Planning Commission
Notice of Meeting
Wednesday, June 17, 2026 – 6:30 p.m.

BAY CITY PLANNING COMMISSION
STAFF REPORT

SPR 26-27 Site Plan Review, 905 S Henry Street
Proposed construction of a new 6,700 square foot paved parking lot that will provide 18 parking spaces.

SITE PLAN
SCALE: 1"=20'-0"

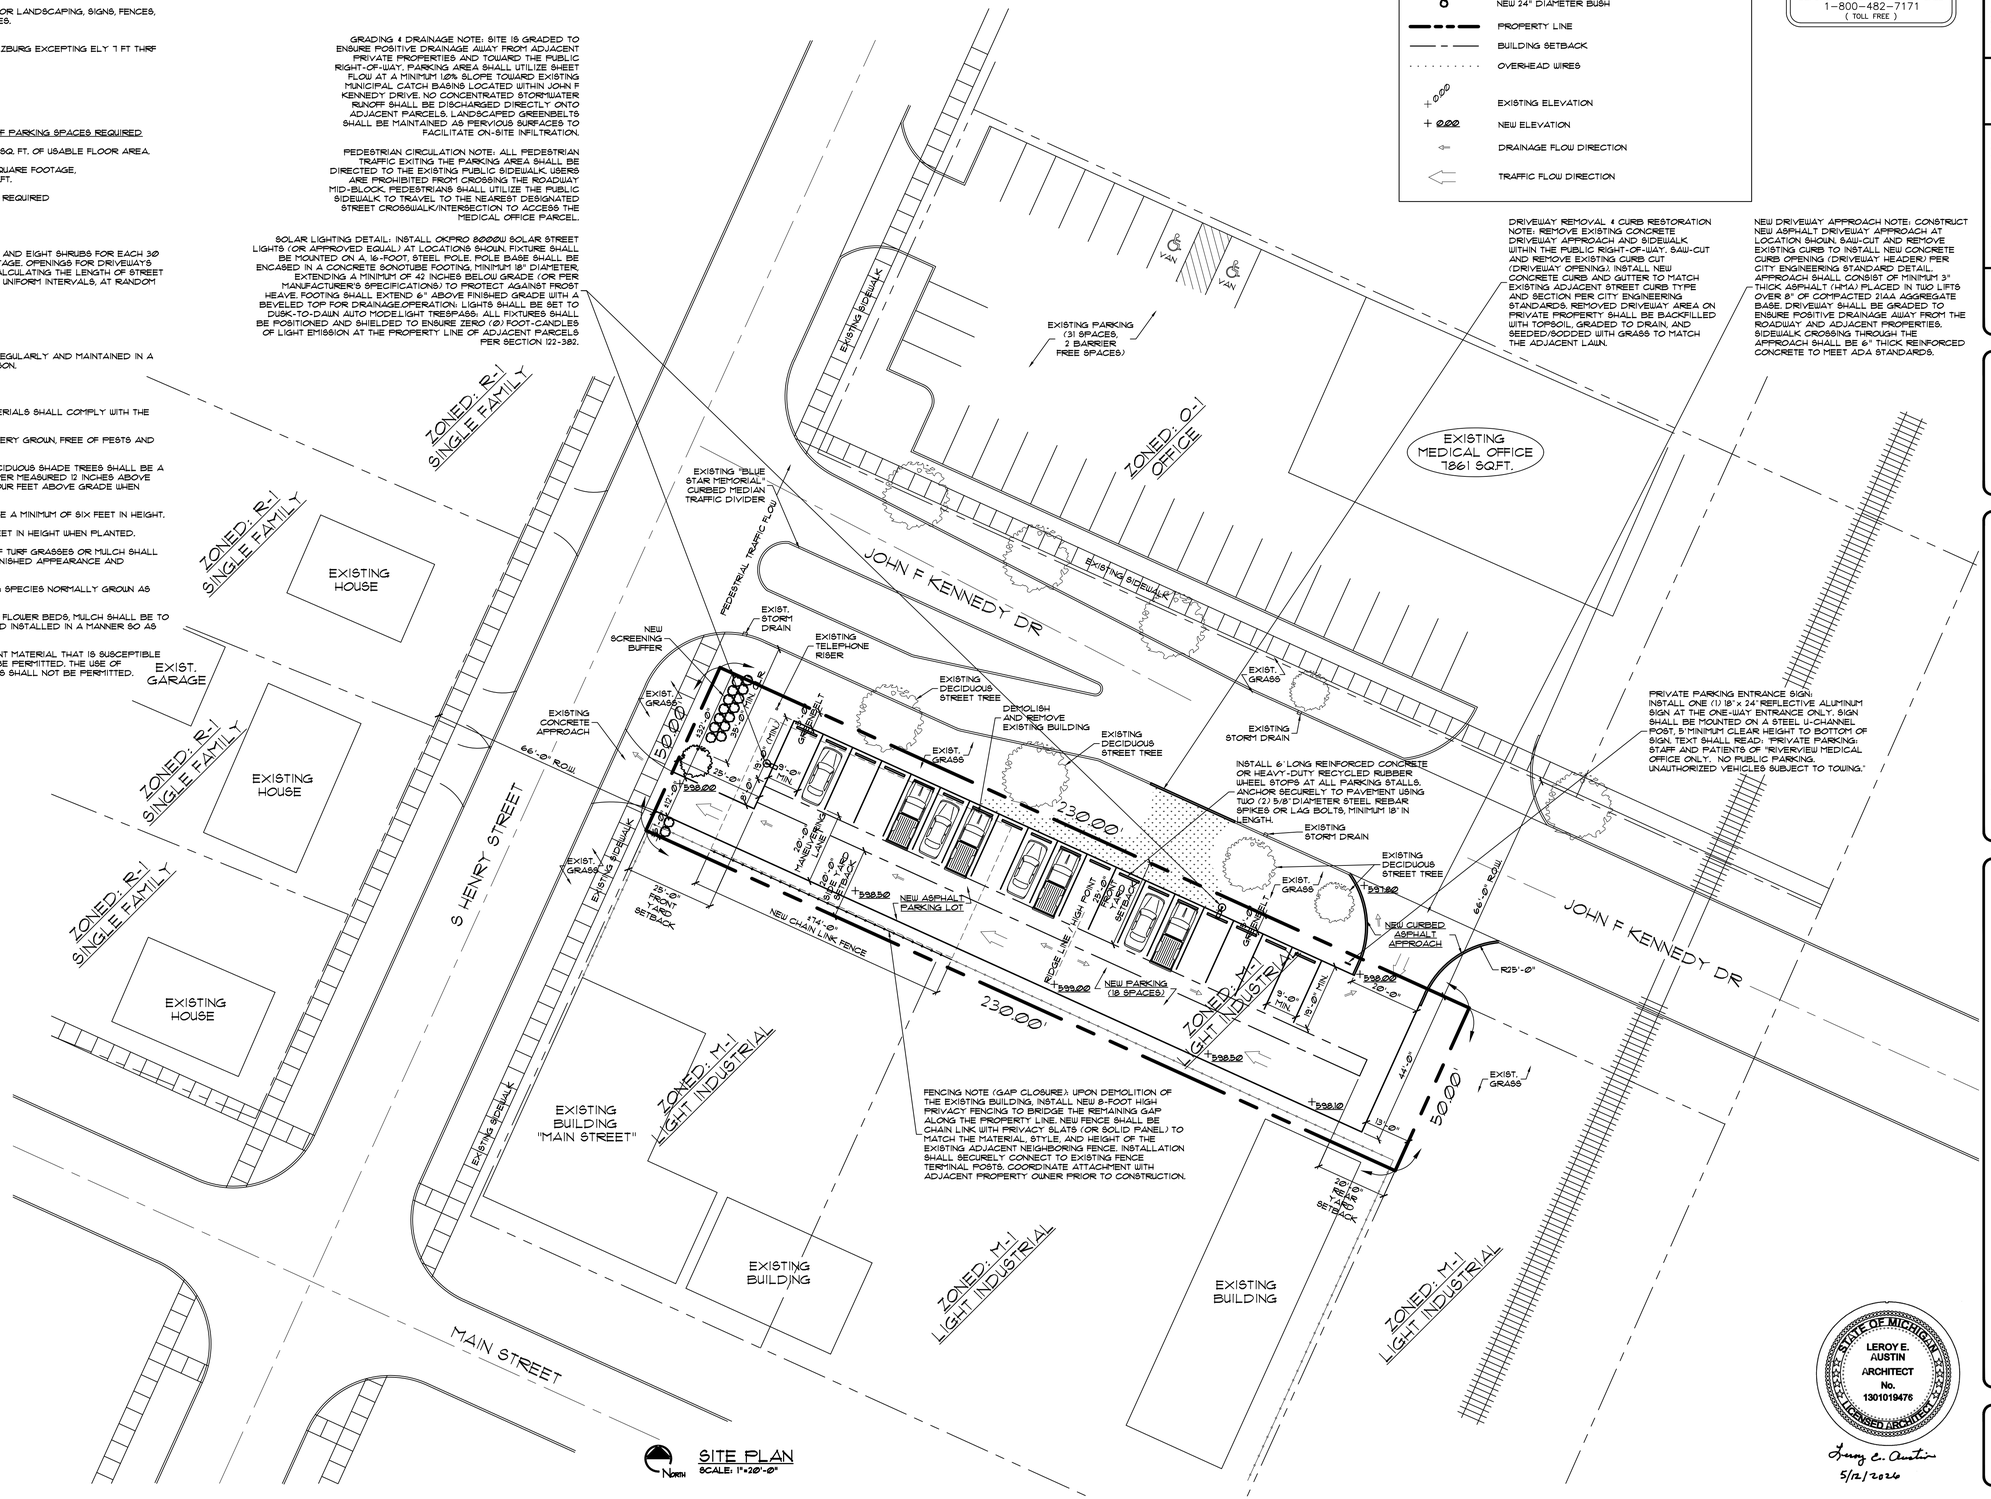
The M-1 zoning district has greater yard requirements than any other zoning district. The setback yard requirements are front: 25'| each side yard 20'|rear 20'. The zoning board of appeals granted dimensional variances for the side yards not being able to be met on a lot having 50' of width. The front and rear setbacks are being met.

Building Code	Subject to plan review process for improvements.
Engineering	The site plan was provided and approved based on the design of the parking lot and access drives submitted. A right of way permit obtained. A stormwater management permit was deemed not necessary due to the size of the area being improved.
Electric	N/A
Fire Marshall	N/A.
Sewer	N/A
Wastewater Treatment	NA

A. The uses proposed comply with applicable zoning district use and dimensional regulations. *Meets requirements.*
B. All elements of the site plan are harmoniously and efficiently organized in relation to the size, shape and character of the lot, the type and size of proposed buildings, the location and layout of landscaping and off-street parking areas, and the character of uses on adjoining properties. *Meets requirements.*

C. The location and design of driveways is safe in relation to streets providing access to the site and in relation to pedestrian traffic. *Comments received from the City Engineer are provided in Part III.*

F. Off-street parking and loading areas comply with the provisions of article XVII. *Parking lot design based on variance allowing a five-foot perimeter landscaping requirement to be met.*

1. Sections 122-305, 326, and 327 are applicable. Based on staff review, the site plan meets site plan requirements provided conditions discussed for a final site plan approval are met.
2. Final site plan approval by city staff prior and Plan Review by building officials.
3. Landscaping in the greenbelt area adjacent to J.F.K. Drive shall include shrubs.
4. Lighting needs to be met.
5. Department review and comments in Part III must be met and a Plan Review application to the Building Department and right of way permit.
